Appendix A.2 – Environment Agency Correspondence

Our ref: KT/2020/127776/01-L01
Your ref: 2813/KT
Date: 13 January 2021

ENVPAC/1/KSL/00360

Custom House, The Terrace, Gravesend, DA12 2DE

Drawing Title:
North Wall replacement to 8.0m AOD

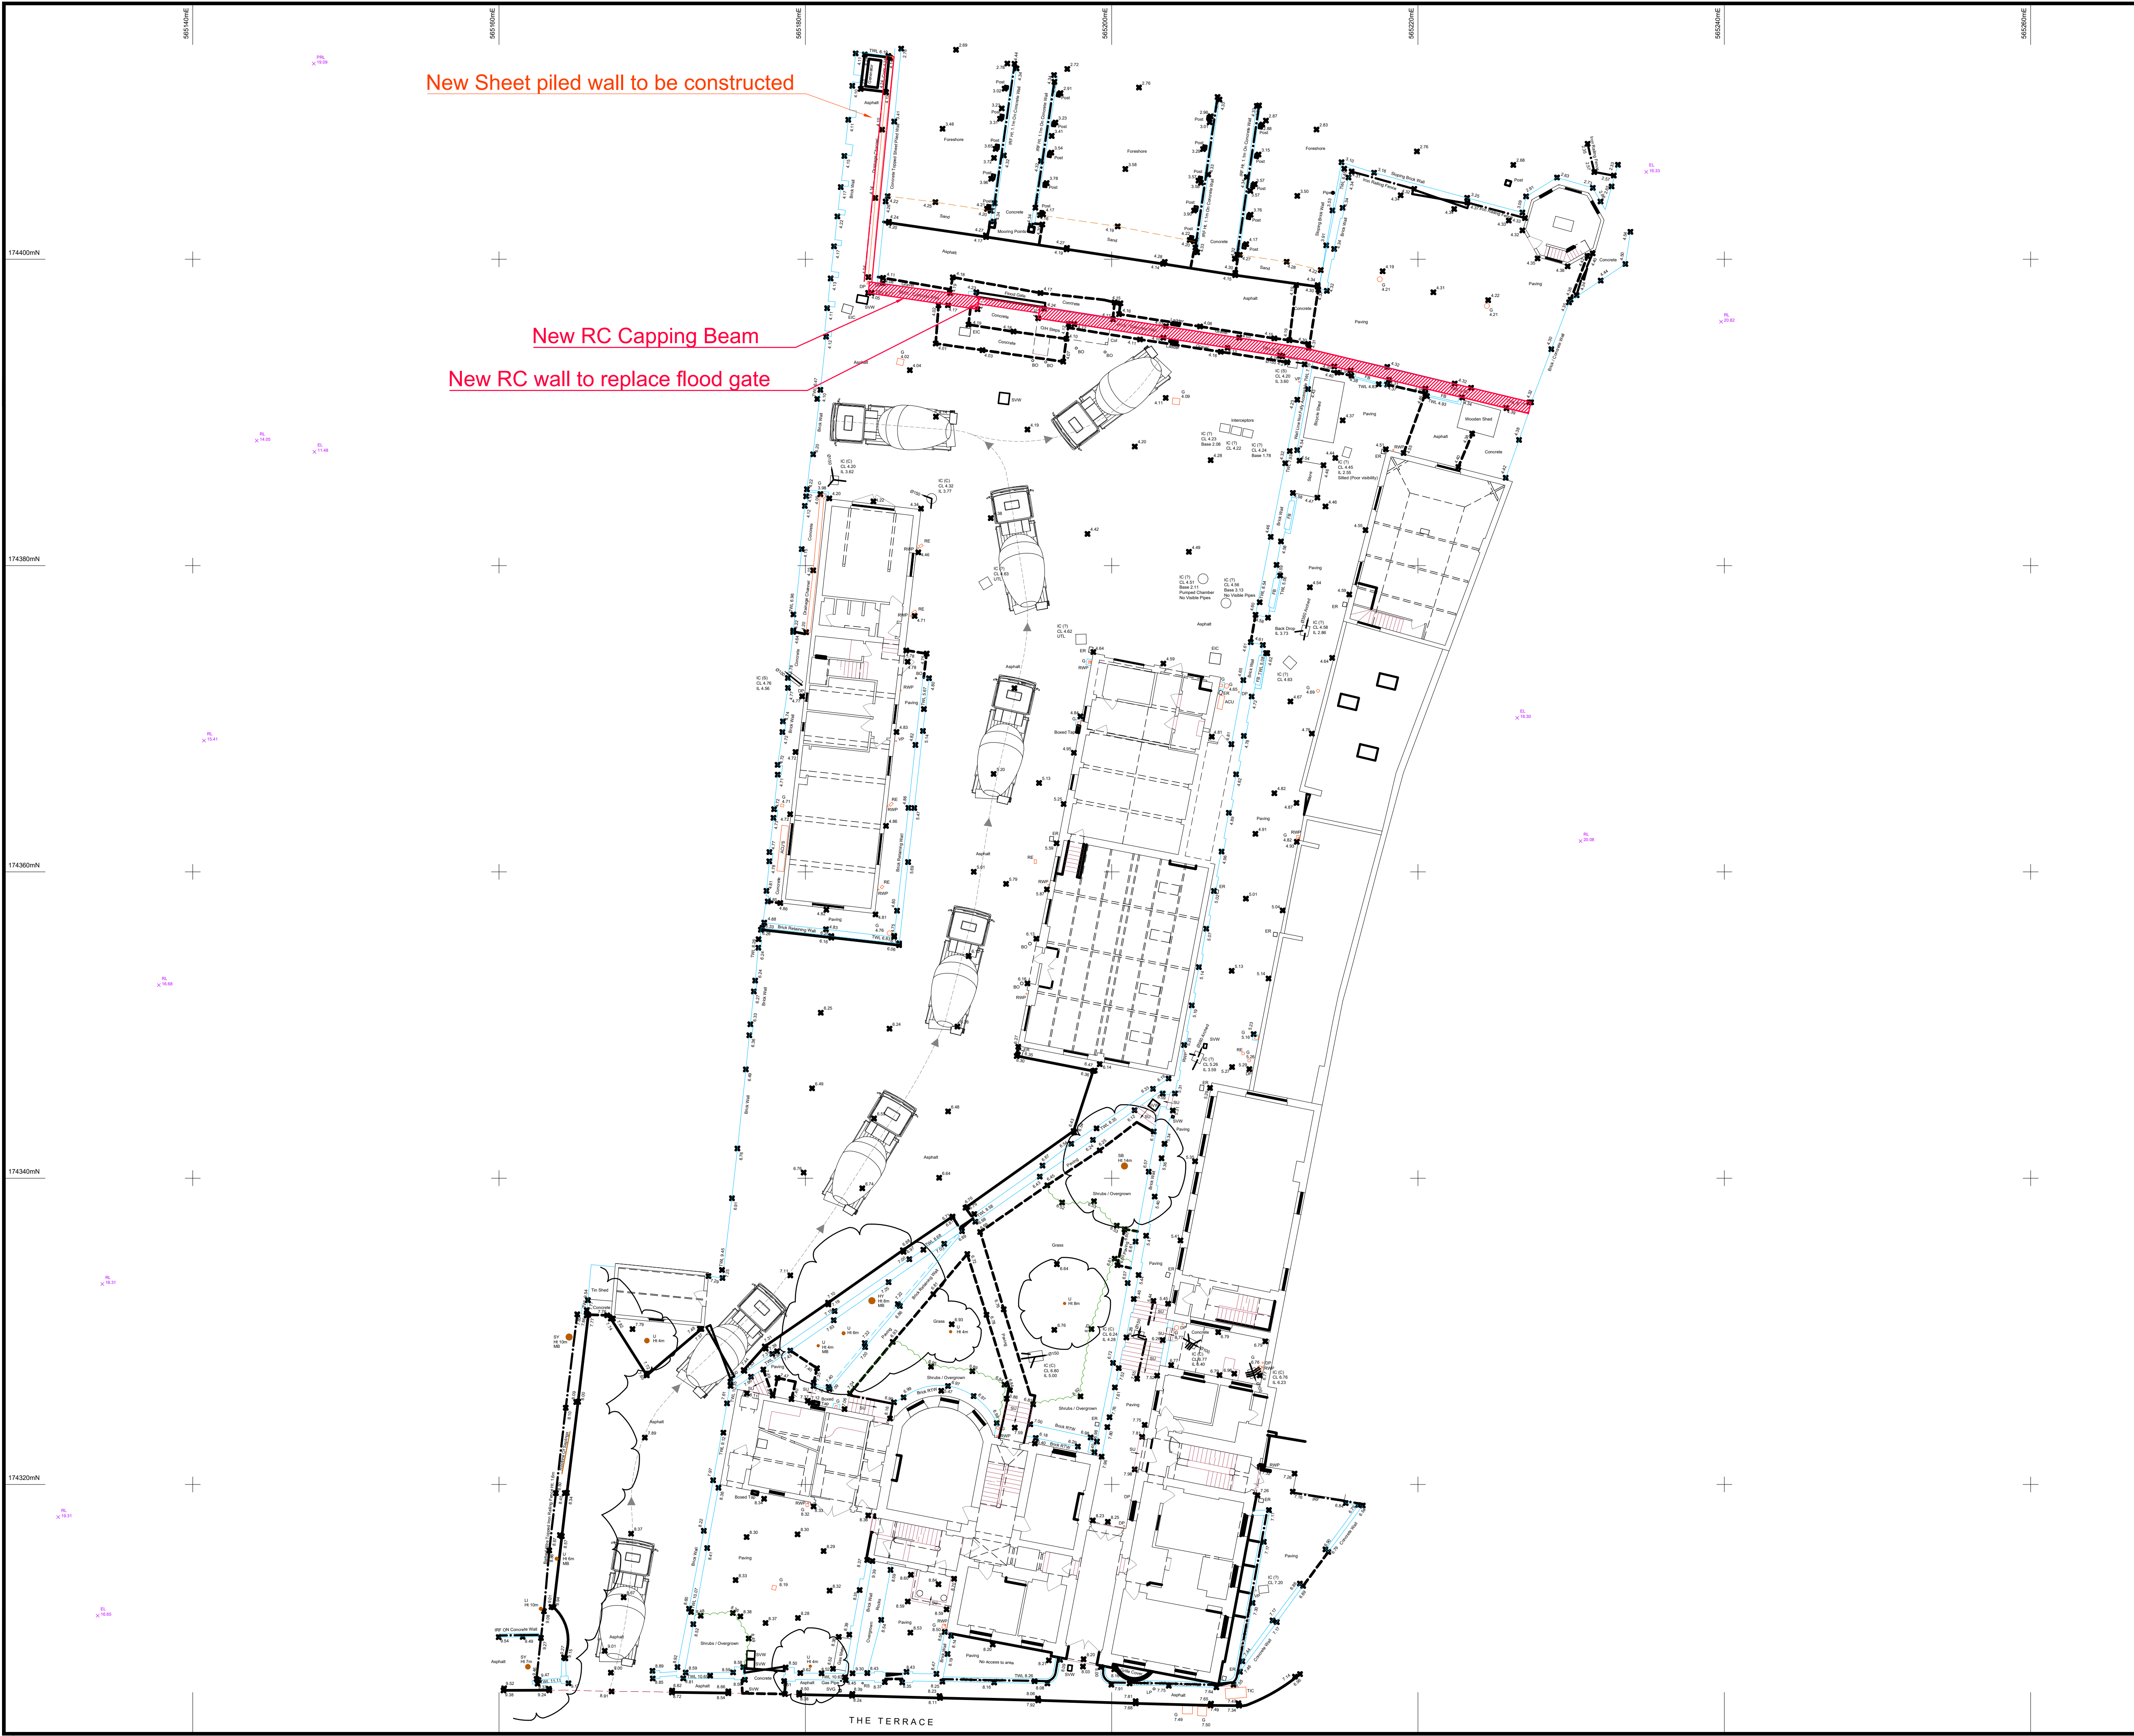
- The proposal should include a detailed plan for how defence levels will be raised to meet 2070 requirements with a 100 year design life. Based on our assessment of the submitted information, the tidal defences do not have sufficient residual life to meet the 100 year requirement or to support the load from further raising to 8.00mAOD. Therefore, a new defence with a crest of no less than 8.00mAOD should be constructed as part of this development.

- We require information on how the 2070 raising will be achieved in the space provided from the landward extent of the flood defence to the first building line. As there are two proposals, this should be shown for the proposal that requires the largest amount of space behind the flood defence to be constructed. i.e. what plant will be required and what are its dimensions, how can this manoeuvre safely within the space provided from the land, does the space for construction adhere to CDM requirements.

- 2.4 The proposed extent of this replacement wall is indicated on A7752-100, the details of the wall interface between new and existing will be provided during the detailed design of this wall. A 90-degree return will be provided at each end of the new sheet piled wall, to enable connection into the existing wall. Buildability is also demonstrated in Appendix D.

2070 Raising to 8.0m AOD

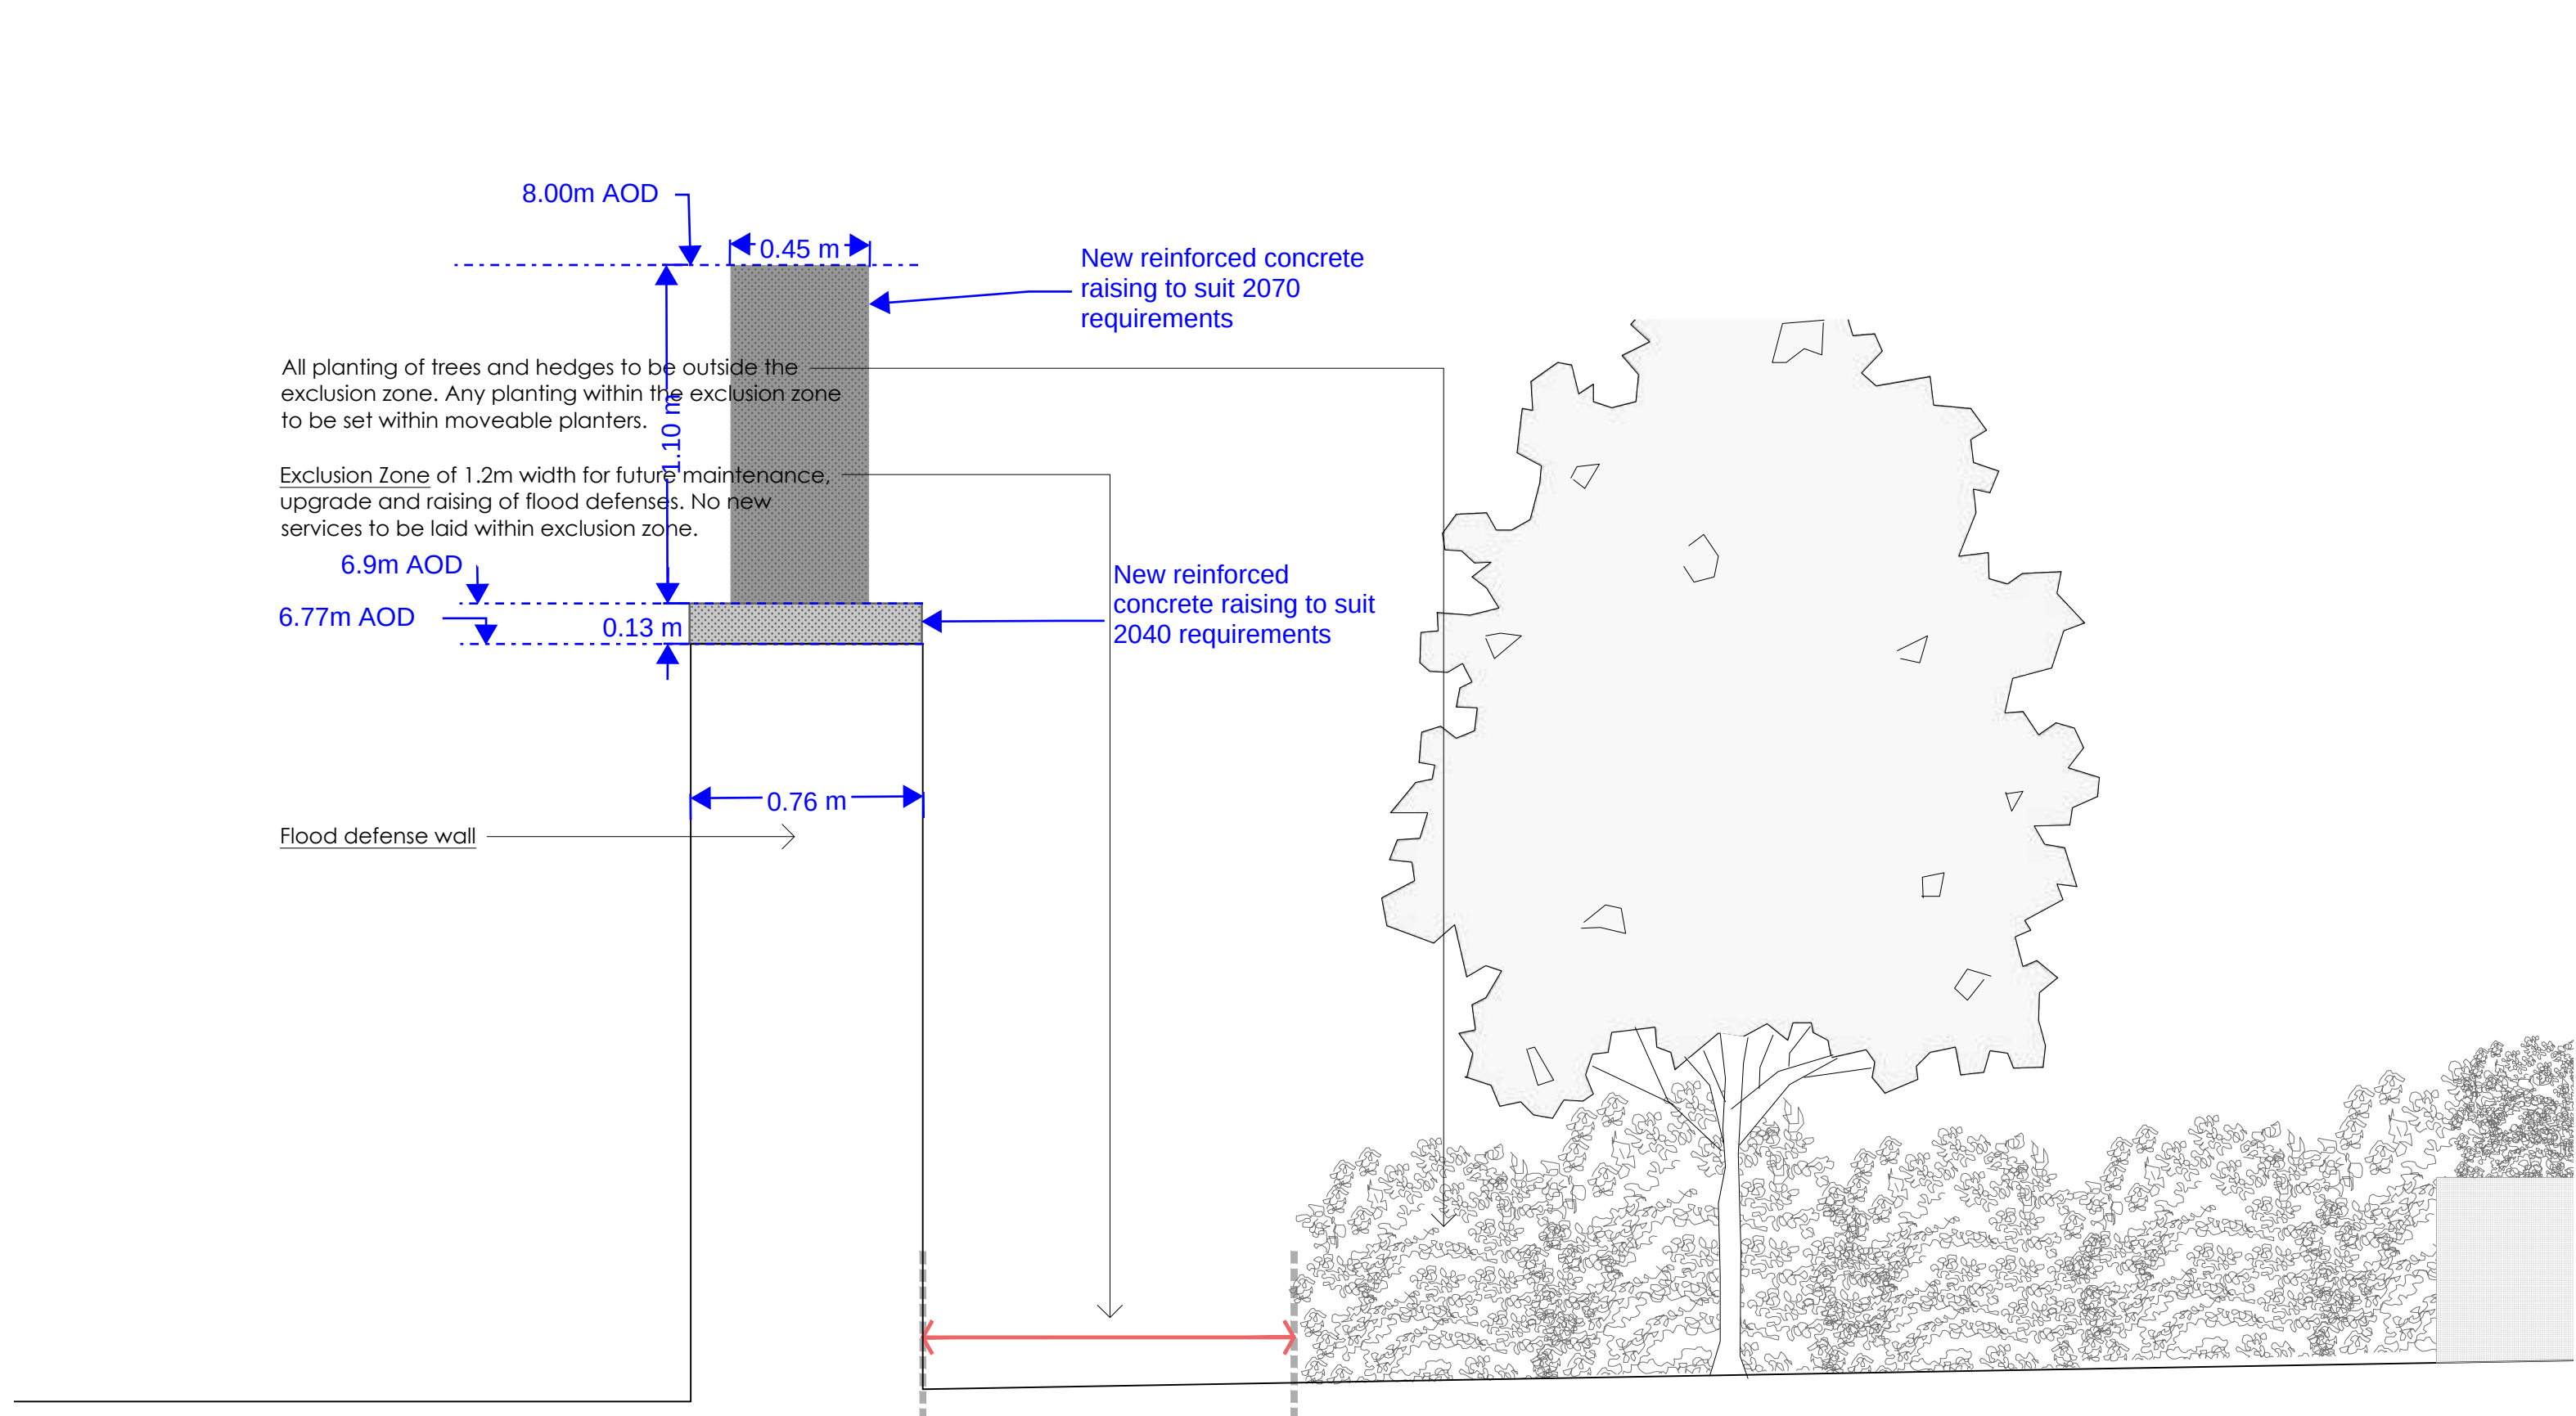
- The applicant is undertaking at least the 2040 defence raising, on the basis the existing defence is demonstrated to have a life of 100 years, also accounting for the performance of the defence with the proposed 2040 raising option – a revised report must detail which option will be chosen and demonstrate buildability.

- Many of the 2040 raising suggestions add load to the flood defence. It has not been demonstrated how the flood defence could take this additional load and how this would affect its performance in achieving an 100 year life without requiring a major intervention.

- The 2040 & 2070 raisings are compatible with one another and are not looked at independently. The dowel bars will provide an adequate key into the existing structure.

- The as built drawings confirm the toe levels of the existing sheet piles.
 - The drawing plan in Appendix A shows space for plant access, contractors' temporary compound, and working access to carry out the 2070 raising
